NUMBER 018

Renault / Accessory Drive / Micro-V® belt GATES REFERENCE: Various Micro-V® belts & their kits MAKE: RENAULT Various Various Various Various Various Various Various

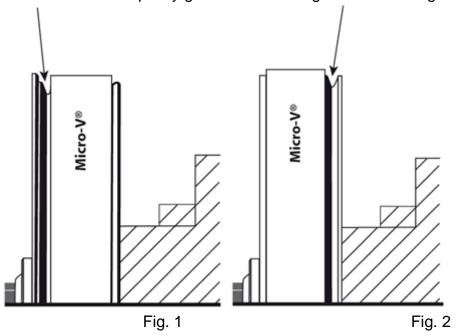
Renault has different engines where a multi-ribbed belt of 5 ribs has to be installed in pulleys with 6 grooves. This can't always be done in the same way.

- On several 1.4 and 1.6 engines (K4J, K4M, K7J, K7M) with air conditioning, originally equipped with a 6PK belt (OE ref. 7700101261 - 6PK1750), Renault has changed to a 5PK belt (OE ref. 7700111671/8200833541 - 5PK1747).
- 2) Also on other engines (F4P, F4R, F5R, K9K) it is quite common to find a 5PK belt together with 6 PK pulleys. (See also Technical Bulletin N° 13 for the 1.5 DCi K9K engine).

As these 5PK belts run in the initially installed 6 groove pulleys, it is important to install the belt in the correct pulley grooves for correct alignment. Especially since it is known that in some cases the multi-ribbed belt was destroyed, and parts entered into the timing belt drive, ultimately causing considerable damages to the engine.

- without airconditioning:
 - power steering pump is belt driven: free pulley groove is groove furthest from engine (Fig 1)
 - power steering pump is electrically driven (not included in the belt drive): free pulley groove is nearest groove to the engine (Fig. 2)
- with airconditioning:
 - free pulley groove is groove nearest to the engine (Fig. 2)

o free pulley groove is nearest groove to the engine (Fig. 2)

free pulley groove is nearest groove to the engine (Fig. 2)
